UNITED STATES PATENT AND TRADEMARK OFFICE

APPLICATION NO.	FILING DATE	FIRST NAMED INVENTOR	ATTORNEY DOCKET NO.	CONFIRMATION NO.
09/384,971	08/30/1999	MASAHIKO KUBOTA	35.C13752	8550

Office Action Summary

DETAILED ACTION

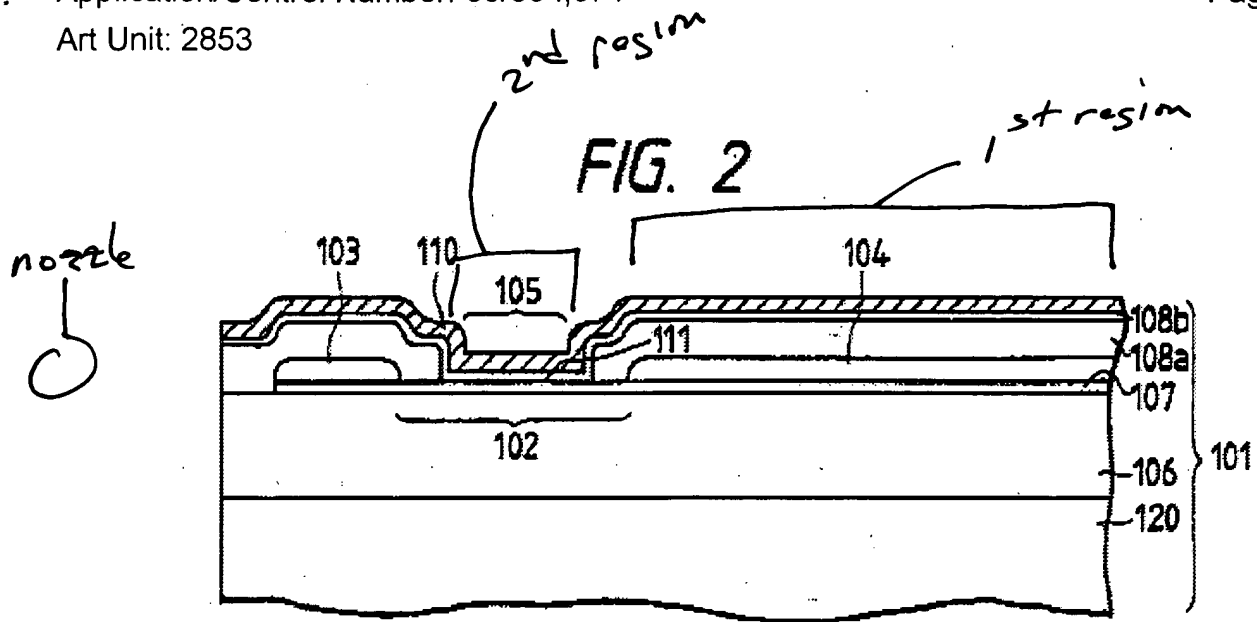
Looking at this figure, it can be seen that in all cases, the second region is closer to the nozzle than the first region.
